<b>Docket Number:</b>	12-AFC-03
<b>Project Title:</b>	Redondo Beach Energy Project
<b>TN #:</b>	201245
<b>Document Title:</b>	BBR RBEP Noise Assessment and Request
<b>Description:</b>	Assess the shortcomings of the AES noise analysis, points out incomplete information on Redondo noise ordinances, and makes requested findings and actions of the CEC.
<b>Filer:</b>	James A Light
<b>Organization:</b>	Building A Better Redondo
<b>Submitter Role:</b>	Intervenor
<b>Submission Date:</b>	11/18/2013 2:41:11 PM
<b>Docketed Date:</b>	11/18/2013

## BBR Redondo Beach Generation Project Noise Assessment and Request

Figure 1: Impact of wind on sound propagation<sup>2</sup>

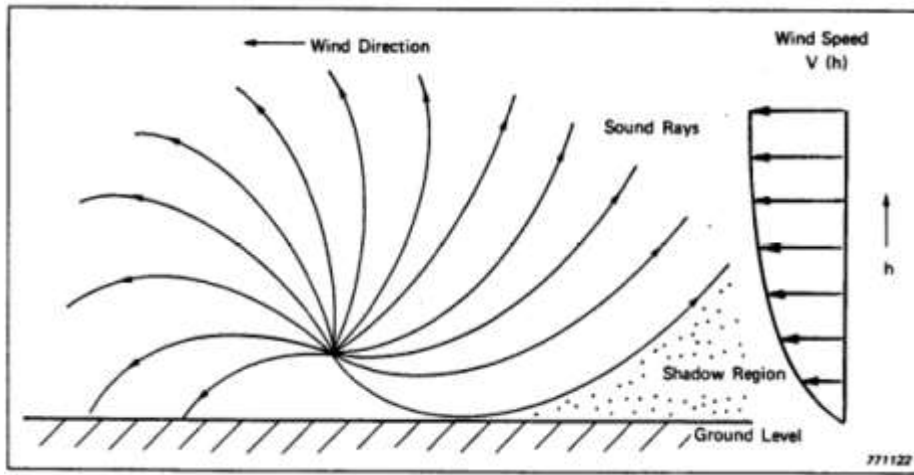
The onshore prevailing winds and the frequent marine layer and inversion conditions tend to reflect noise back to the ground. *"A sound wave propagating in the direction of the wind will be bent downward."*<sup>4</sup> The impact of wind is shown in Figure 1.

Figure 2: Impact of overcast conditions on sound propagation<sup>4</sup>

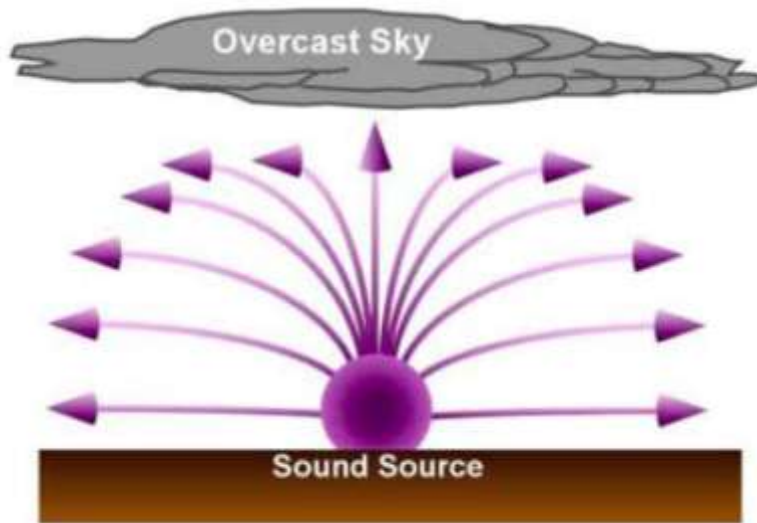
Figure 2 demonstrates that overcast conditions cause sound to propagate laterally rather than directly away from the sound source.

In addition to onshore winds, temperature inversions and marine layer are prevalent in Redondo Beach. In fact, the overcast conditions prevail so often in early late Spring and early Summer that the condition is referred to as "June Gloom".

*"Under conditions of temperature inversion (temperature increasing with increasing height), the sound waves will be refracted downwards, and therefore may be heard over larger distances."<sup>3</sup>*

Figure 3: Impact of elevation on sound propagation<sup>6</sup>

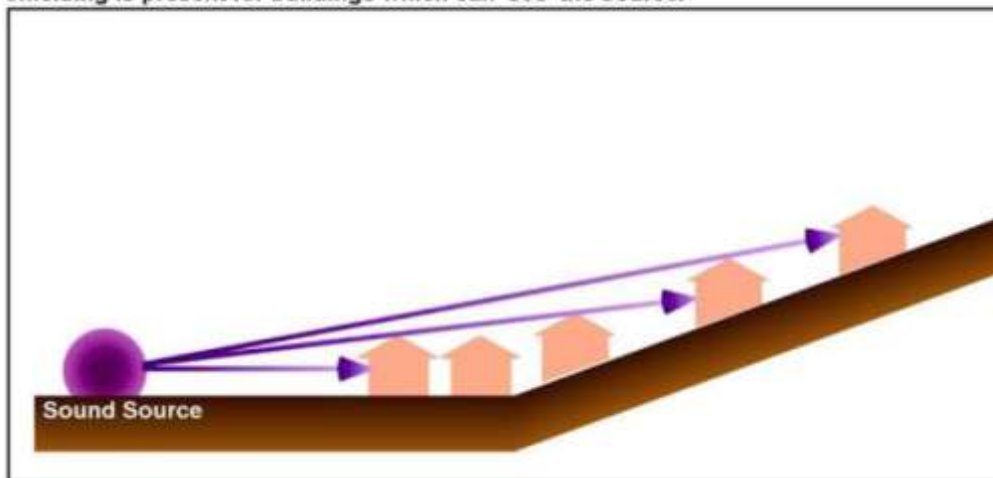
While AES proposes a wall around their new plant, mainly for visual purposes, but it may provide some sound attenuation if designed properly. However, since the terrain rises so much above the site it would be both impractical and undesirable (from a visual impact perspective) to build a high enough wall to prevent "line of sight" from the plant to homes higher up in the surrounding terrain. Figure 3 demonstrates the issue.
